# Safety Evaluation Report

related to the operation of  
Shearon Harris Nuclear Power Plant,  
Unit No. 1

Docket No. STN 50-400

This report, Supplement No. 3 to the Safety Evaluation Report for the application filed by the Carolina Power and Light Company and North Carolina Eastern Municipal Power Agency (the applicants) for a license to operate the Shearon Harris Nuclear Power Plant Unit 1 (Docket No. 50-400), has been prepared by the Office of Nuclear Reactor Regulation of the U.S. Nuclear Regulatory Commission. This supplement reports the status of certain items that had not been resolved at the time of publication of the Safety Evaluation Report and Supplement Nos. 1 and 2.

Figure 9.1 Circuit design wherein resultant faults could result in loss of needed power

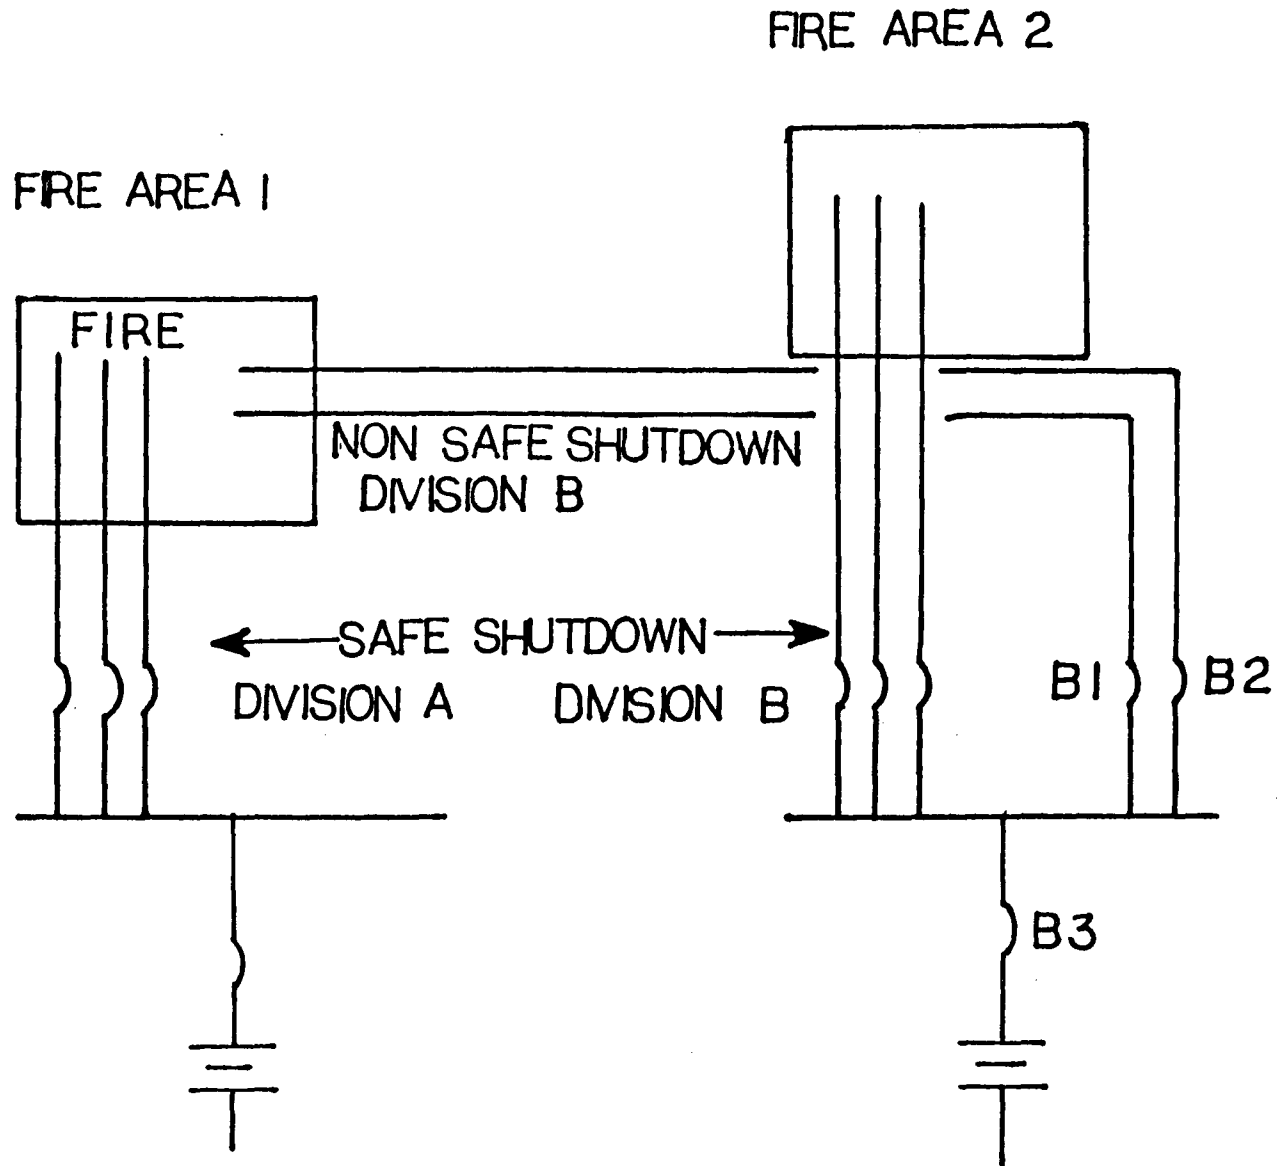
The staff's concern regarding the potential for multi-high impedance faults in circuits that would result in the loss of power to safe shutdown equipment is shown in Figure 9.1. Figure 9.1 contains a sketch of a circuit design that could result in the loss of needed power to safe shutdown equipment. As can be seen in this figure, redundant divisions of safe shutdown cables are properly separated in accordance with Appendix R criteria. However, a fire in fire area A could result in loss of division A safe shutdown equipment and cause damage to non-safe-shutdown cables associated with the division B bus. Further, the individual fault current resulting from the fire damage in the non-safe-shutdown cables may not be enough to trip the individual breakers ( $B_1$  and  $B_2$ ), but the sum of the faults may be sufficient to trip the main breaker,  $B_3$ . If this were to occur, the division B bus and the corresponding redundant division B safe shutdown equipment would be lost. The applicants must demonstrate that multi-high impedance faults in ac power circuits resulting from a single fire cannot result in the loss of function of any safety-related system as outlined above.
